Hotline Fix – MQ13-002, QE13-001

Vehicle logging various DPF related DTC's due to temperature sensor failure.

Revision E -03/09/2021

MQ Triton, QE Pajero Sport

Wiring rework instructions:

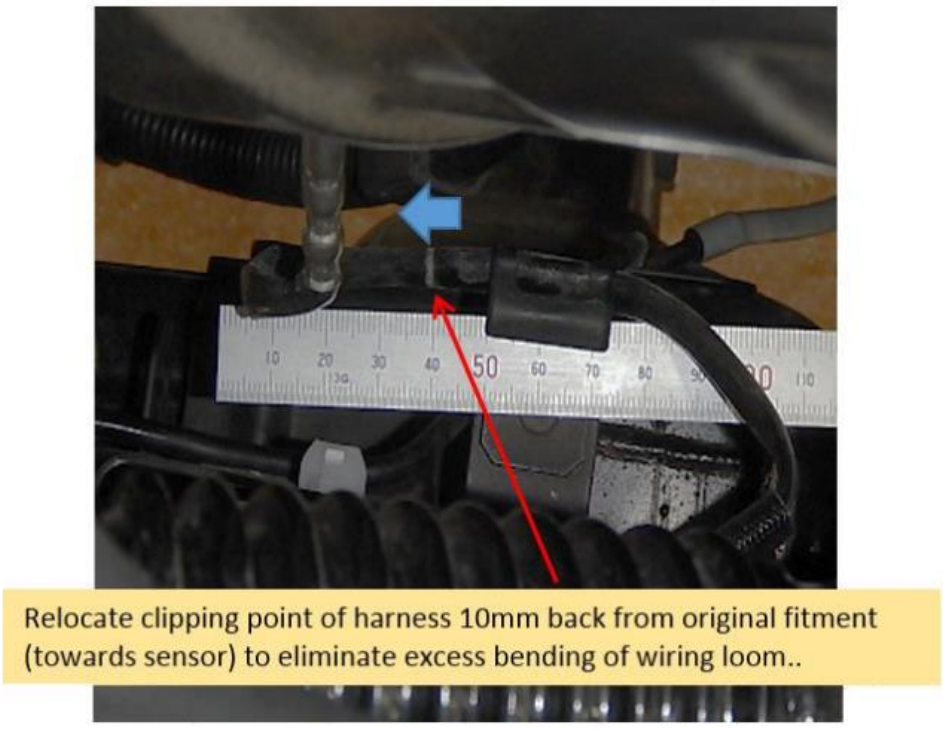
Relocate clipping point of harness 10mm back from original fitment (towards sensor) to eliminate excess bending of wiring loom..
